| MODEL | REV | CHANGE LIST |
|---|---|---|
| NT11 M/B BOARD | 1A | FIRST RELEASE |

| Quanta Computer Inc. | PROJECT : NT1 | PCBA NO.31MNT1MB0010 | REV :2B | DOC. NO: |

# NT1 - Block Diagram

Rev 1A
Date: Monday, April 21, 2003
Sheet 12 of 33

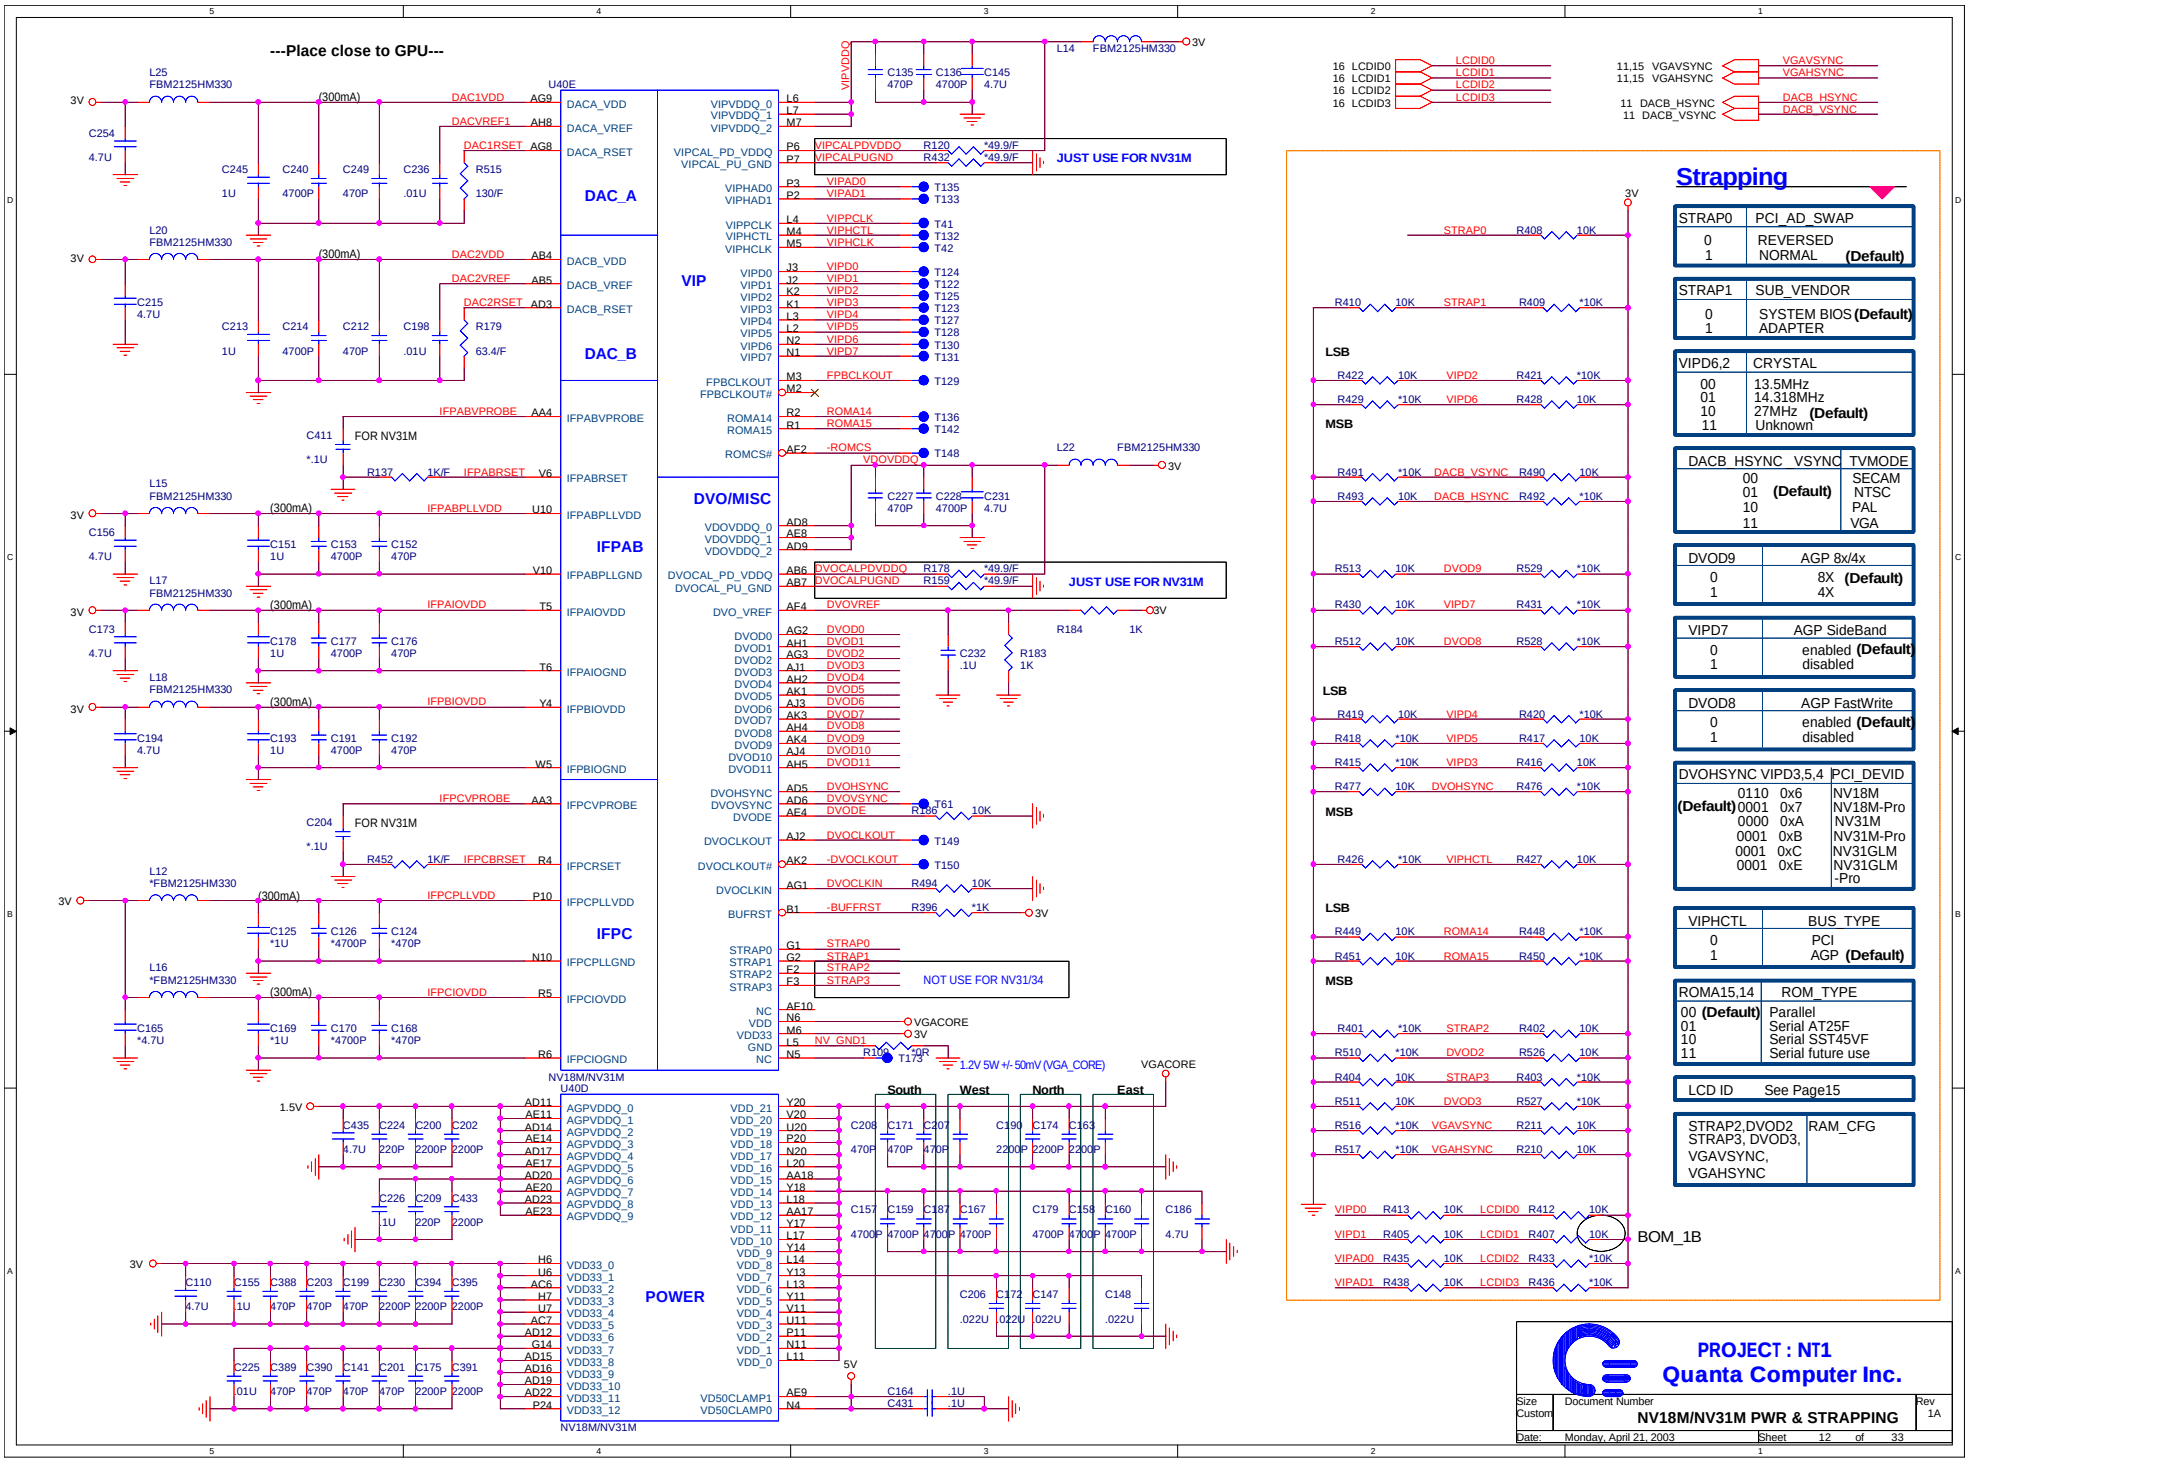
| MODEL | REV | CHANGE LIST |
|---|---|---|
| NT11 M/B BOARD | 4A | PAGE 11 --- ADD 2ND CHIP SELECT TO SUPPOT TWO CS TYPE 8Mx32 DDR VRAM. ADD NV31M PIN P27 AND D14 TO VRAM FOR2ND CS.<br>PAGE 12 --- THE STRAPPED PINS NEED TO CHANGE FOR TWO CS TYPE VRAM; TO BE CONFIRMED BY NVIDIA. (TO BE CONFIRMED)<br>PAGE 13 --- ADD 2ND CHIP SELECT TO SUPPOT TWO CS TYPE 8Mx32 DDR VRAM. ADD VRAM PIN L3 AS 2N CS.<br>PAGE 26 --- INCREASE USB PORT POWER FROM 0.5A TO 1A TO SUPPORT USB HDD DEVICE. SHORT U33/U34 PIN 5 AND 8 TO INCREASE POWER.<br>PAGE 28 --- CHNANGE BAT-IN INDUCTOR TO AVOID ME INTERFENCE IN SI1 UNIT. USE 2 FBMJ3216HS480 TO REPLACE FBMH453281-T.<br>PAGE 29 --- ADD VGA2.5 DISCHARGE CIRCUIT TO MEET NVIDAI POWER SEQUENCE. ADD PQ74, PQ74, R172 AD R172 TO CONTROL DISCHARGE TIME.<br>PAGE 30 --- FINE TUNE VGACORE CIRCUIT.<br>1. CHNAGE PU1 FROMLM358 TO LMV321. (POWERED BY 5V)<br>2. CHANGE PR1 FROM 10K TO 4.7K AND ADD PR173 4.7OHM RESISTOR TO IMPROVE RESPONSE TIME.<br>3. CHANGE PC80 BULK CAPACITOR FROM 100U TO 330U FOR BIG CURRENT.<br>4. ADD PC175 100PF TO FLTER HIGH FREQ NOISE. |

0.1U/25V
PC107
0.1U/25V
28 REFON
PROJECT : NT1
Quanta Computer Inc.
Size
Custom
Document Number
BATTERY CHARGER
Rev
2A
Date:
Monday, April 21, 2003
Sheet
28
of
33

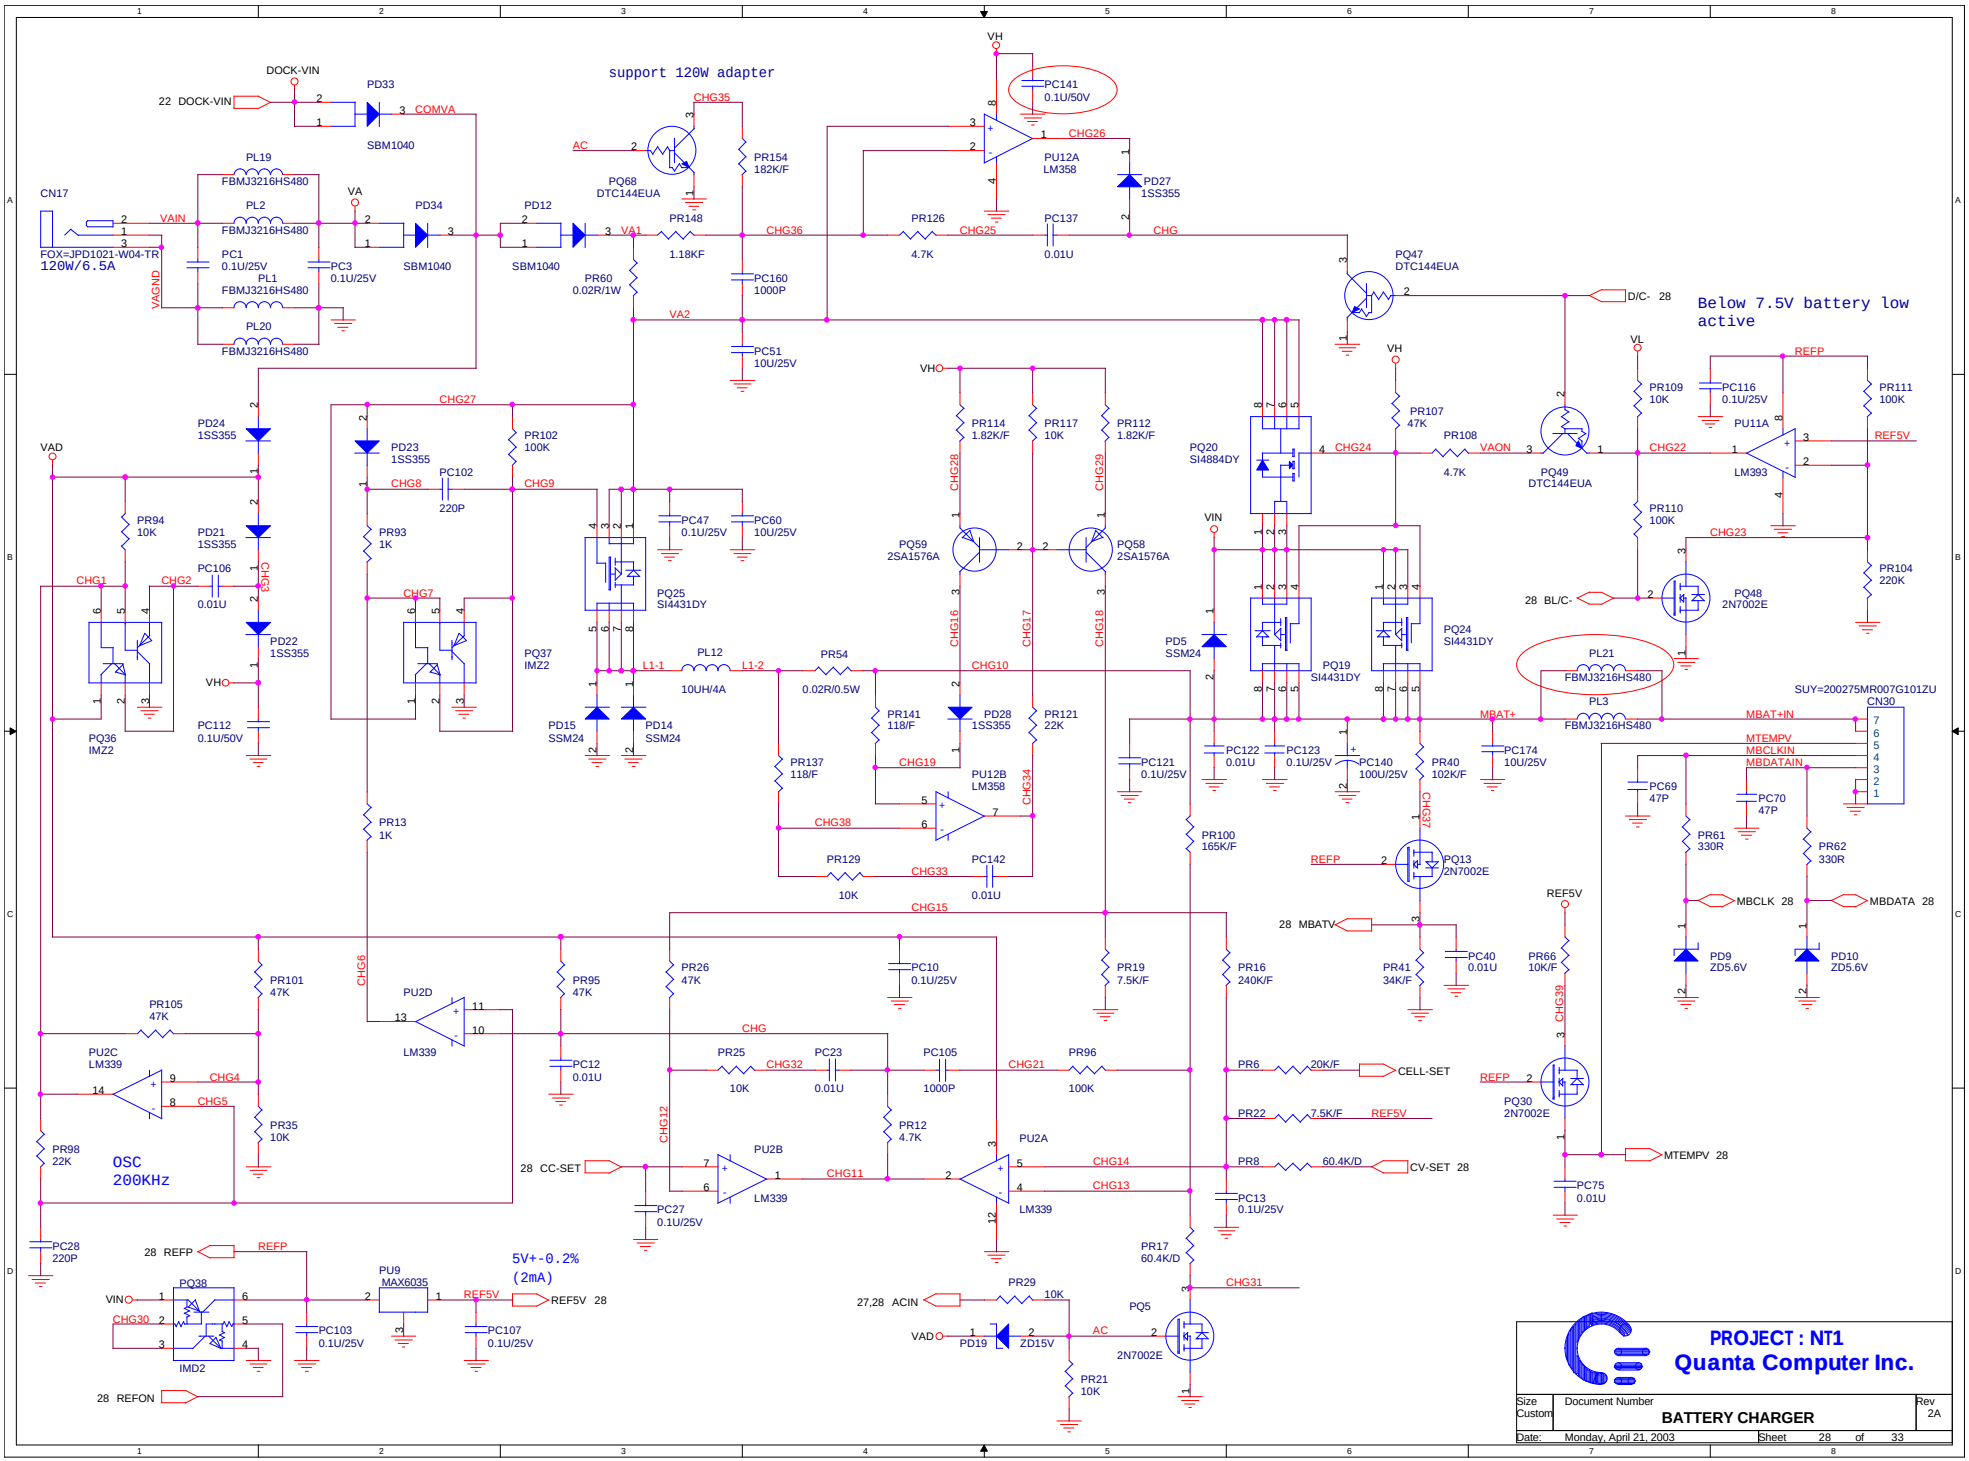
| MODEL | REV | CHANGE LIST |
|---|---|---|
| | 3A | PAGE 3 --- ADD 200ohm resistor on thermal IC power pin (Maxim recommand)<br>PAGE 4 --- Change some SPD VGA pin to GND as INTEL design guide.<br>PAGE 10 --- Change VGA thermal IC to MAX6649 (nVidai recommand).<br>PAGE 15 --- Reserve VGA2.5V discharge circuit.<br>PAGE 27 --- Reserve -LID pin also routing to EC. (SW request)<br>PAGE 28 --- Change PR16/PR100 value for charger function. |

Sheet 32 of 33

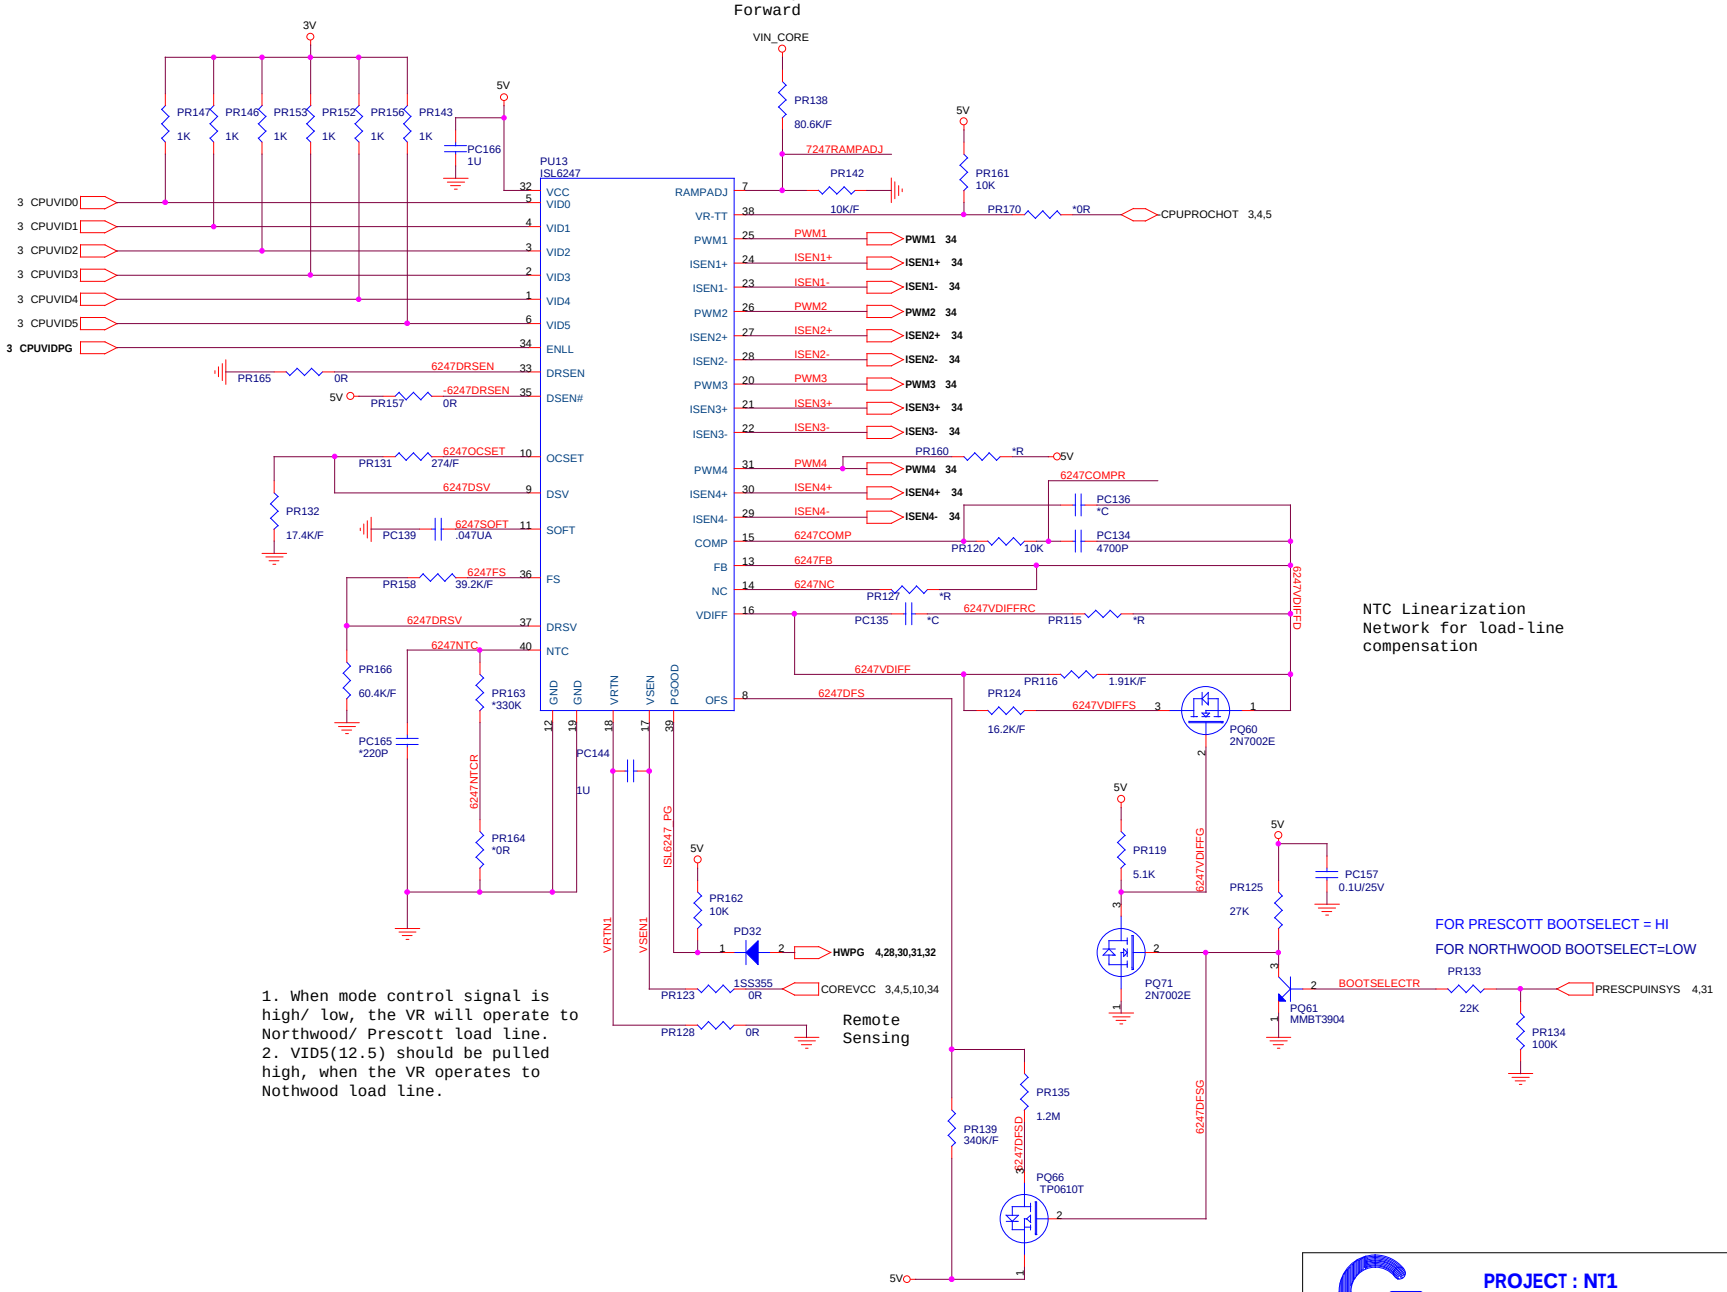
| MODEL | REV | CHANGE LIST |
|---|---|---|
| | 2A | PAGE 2 --- CHANGE R577 PULL-UP VOLTAGE TO COREVCC TO AVOID SYSTEM SHUTDOWN WHEN FIRST POWER-ON<br>CHANGE R546 PULL-UP VOLTAGE CPUVIDVCC AS INTEL CRB RECOMMANDATION<br>RESERVE 3V AS CONTROL OF CPUVIDVCC FOR THE ALTERNATIVE METHOD TO TURN-ON CPUVIDVCC<br>CHANGE L46/L47 TO 10uH INDUCTOR AS CRB RECOMMANDATION<br>PAGE 3 --- CHANGE FSBSEL0 TO PULL-UP FOR CORRECTIVE FSB DETECTION FROM CPU<br>PAGE 6 --- CHANGE ICH5 PINB3/PINC2 TO GND AS INTEL RECOMMANDATION<br>PAGE 7 --- CHANGE SODIMM DQMx SIGNAL AS CURRENT PCB REWORK. IT ALSO CAUSE SOME VTT PULL-UP DELETED.<br>CHANGE CHANNEL B SODIMM ADDRESS TO 02 AS INTEL CRB RECOMMANDATION.<br>PAGE 9 --- CORRECT RTC 32.768 XTAL FOOTPRINT<br>RESERVE 1632PG AS SUSPEND POWER WELL CONTROL PIN TO FIX FIRST POWER-ON TOO LONG ISSUE<br>PAGE 10 --- FIXED R205 TO GND FOR 8XAGP SETTING ON NV18M/NV31M<br>PAGE 15 --- CHANGE STRAPING SETTING PER NVIDIA RECOMMANDATION.<br>CHANGE LID SWITCH TO CABLE TYPE<br>INCREASE R343 TO 47K FOR PROPER LCD BACKLIGHT CONTROL<br>PAGE 16 --- CHANGE CB710 IDSEL TO AD17<br>PAGE 18 --- CHANGE 4-IN-1 FFC CONNECTOR TYPE FOR EASY INSATLLATION FFC CABLE<br>PAGE 19 --- CHANGE 1394 ISDEL TO AD18<br>PAGE 20 --- CHANGE LAN IDSEL TO AD16<br>FIXED LANVDD25 CONNECTION ERROR IN DB1 PCB<br>PAGE 21 --- CHANGE MINIPCI IDSEL TO AD19<br>PAGE 22 --- CHANGE MC7 TO 0.047U FOR NO DIAL-TONE ISSUE<br>PAGE 23 --- REMOVE R620/R626/R3223 TO IMPROVE MIC QUALITY<br>CHANGE CN8 PIN ASSIGNMENT FOR TRACE ROUTING<br>PAGE 24 --- CHANGE R263 PULL-UP TO 3V<br>PAGE 25 --- REVERSE HDD0-HDD7 PIN ASSIGNMENT FOR DESIGN MISTAKE<br>CHANGE FAN1ON/FAN2ON TO FIX FAN NOISE ISSUE<br>REMOVE ALL FAN3 RELATIVE COMPONENT<br>PAGE 26 --- CHANGE ALL BUTTON SWITCH TYPE FOR M/E LIMIATION<br>ADD 2 EXTRA POWER-ON LEDS AND BUFFERS<br>CHANGE Q23 TO 2N7002 FOR DRIVING ISSUE<br>CHANGE CN1 CONNECTOR TYPE FOR M/E LIMIATION<br>PAGE 27 --- CHANGE K/B FFC CONNECTOR TYPE FOR EASY INSTALLATION<br>CHANGE U48 FOOTPRINT TO FIX LAYOUT MISTAKE<br>RESERVE PR8 FOR MX0-MX7 PULL-UP<br>PAGE 28 --- ADD PD33/PD34 FOR CABLE DOCK DESIGN<br>FINE-TUNE PR148/PR60 FOR BATTERY CHARGER<br>PAGE 29 --- ADD Q51 FOR LAN POWER CONTROL<br>PAGE 32 --- CHANGE PR123/PR128 FOR CORRECT COREVCC SENSE |
